DEPARTMENT OF TRANSPORTATION**Federal Aviation Administration****14 CFR Parts 25 and 33**

[Docket No. FAA–2010–0636; Amendment Nos. 25–140 and 33–34]

Airplane and Engine Certification Requirements in Supercooled Large Drop, Mixed Phase, and Ice Crystal Icing Conditions**AGENCY:** Federal Aviation Administration (FAA), DOT.**ACTION:** Final rule.

FIGURE 1 — Appendix O, Freezing Drizzle, Liquid Water Content

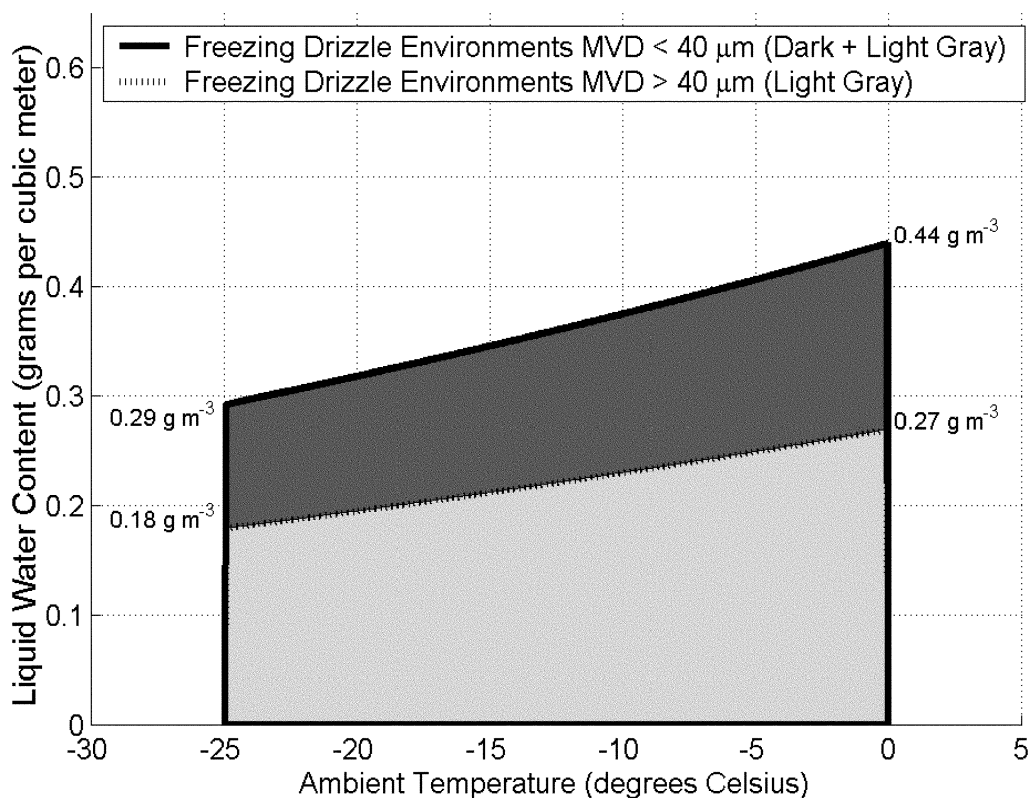
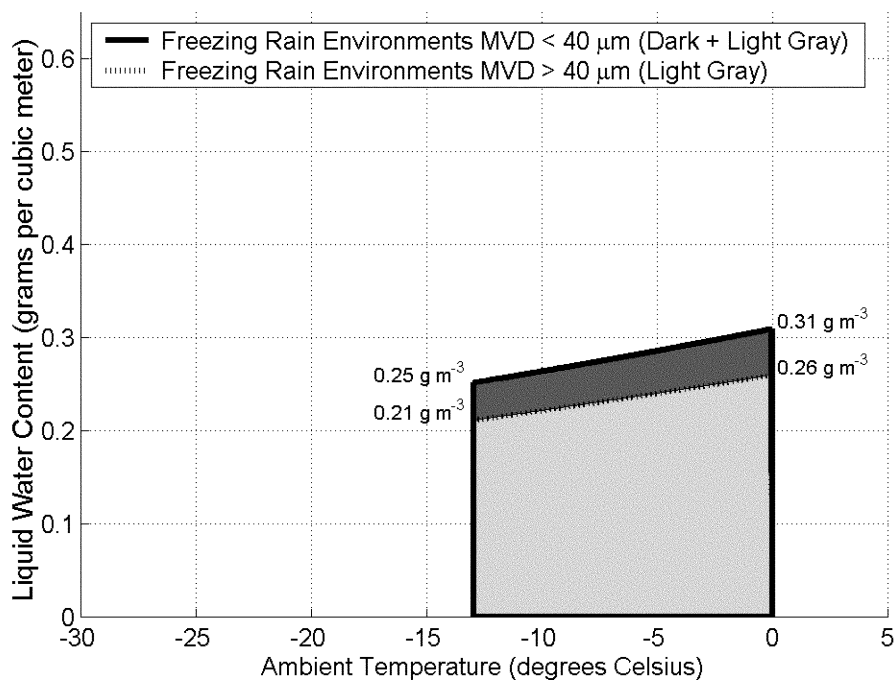
Several commenters said that proposed figures 1, 4, and 7 in appendix O of the NPRM were different than what was proposed by the IPHWG, and that the FAA did not provide an explanation for those differences. The commenters also noted that the higher LWC contained in the figures proposed in the NPRM could have a significant impact on an applicant's design. GSIS specifically noted that the higher water content defined in appendix O will have

In response to other comments, figures 1 and 4 of appendix O have been revised in this final rule to reflect the LWC proposed by the IPHWG. As a result, freezing drizzle conditions with a median volume diameter (MVD) greater than 40 microns fall within the adverse region that would be identified using the University of Wyoming LWC/drop size technique. No changes to appendix O were made as a result of these comments.

We agree. We reviewed the figures proposed in the NPRM and the data used by the IPHWG to generate the figures. We revised figures 1 and 4 to reflect the lower water content values proposed by the IPHWG, but the water content in appendix O is still higher than within appendix C at the same temperature. The higher water content may increase the power requirements for some electro-thermal deicing system designs, but not to the extent that may have been necessary with the water contents proposed in the NPRM. The environmental conditions defined in appendix O are valid conditions that will need to be considered for applicable future designs. Our review of the data used to generate the scaling factor curve in figure 7 indicates that the figure 7 proposed by the IPHWG in the task 2 working group report was incorrect; ⁴ figure 7 in the NPRM was correct. Therefore, figure 7 in this final rule remains as proposed in the NPRM. Figures 1, 3, 4, and 6 of appendix O in this final rule have been revised to identify the corner data points for clarity.

FIGURE 6 — Appendix O, Freezing Rain, Temperature and Altitude

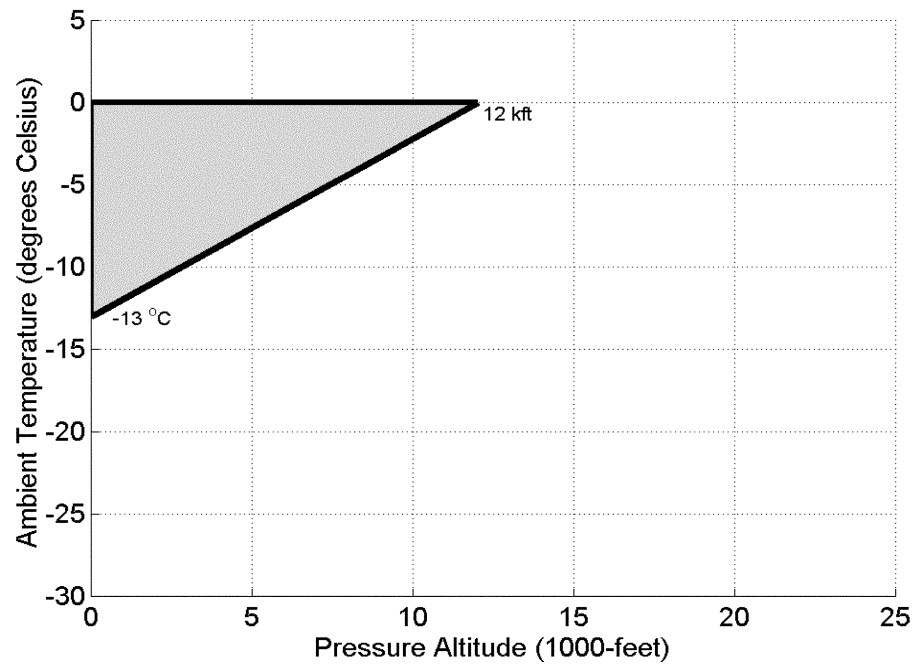
One commenter, a private citizen, noted that the NPRM did not identify the vertical extent for part 25, appendix O, figure 6. We disagree. The pressure altitude range and vertical extent for freezing rain were provided in appendix O, part I, paragraph (b) in the NPRM located under figure 3. We clarified appendix O, part I, by moving all of the general text describing the meteorological parameters, including vertical extent, ahead of the figures.

FIGURE 7 — Appendix O, Horizontal Extent, Freezing Drizzle and Freezing Rain

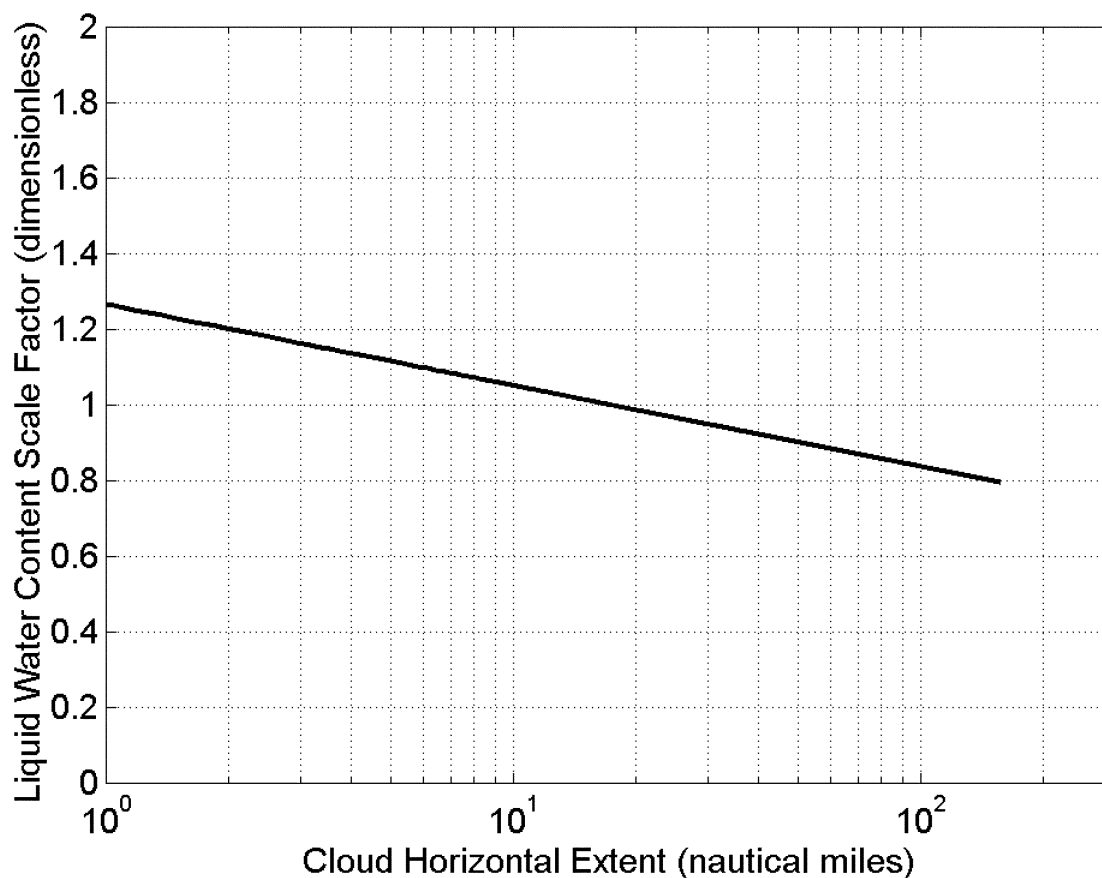
Boeing suggested a change to appendix O, part I, paragraph (c), to add an equation to determine the LWC for

We agree that adding such an equation could be beneficial. The equation proposed by Boeing, however, expressed horizontal distance in kilometers, which would be inconsistent with other figures in appendix O. Instead of the equation proposed by Boeing, we added to appendix O, part I, paragraph (c), a similar equation that uses units of nautical miles.

FIGURE D3 — Exposure Length Influence on TWC

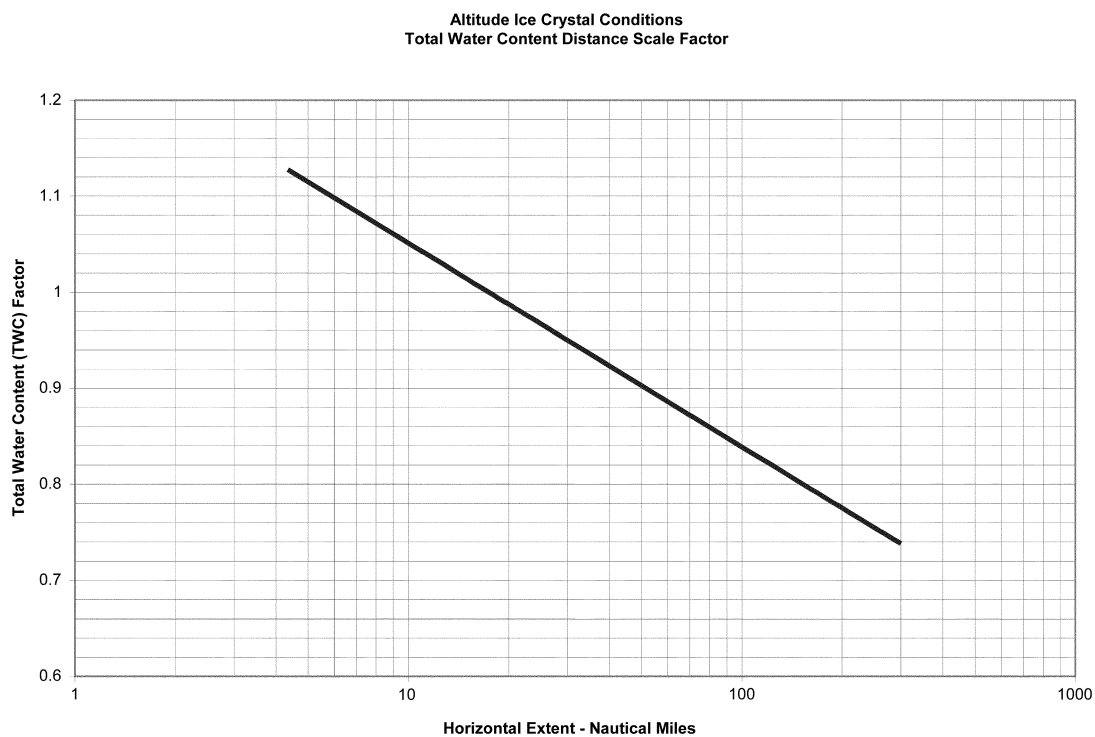
Snecma commented that the y-axis value in proposed part 33, appendix D, figure D3, was incorrect. The value should be 0.6 but the NPRM showed the value as zero.

33, appendix D, figure D3, to depict the correct axis values. The lowest x-axis value is now 1 and the lowest y-axis value is now 0.6.
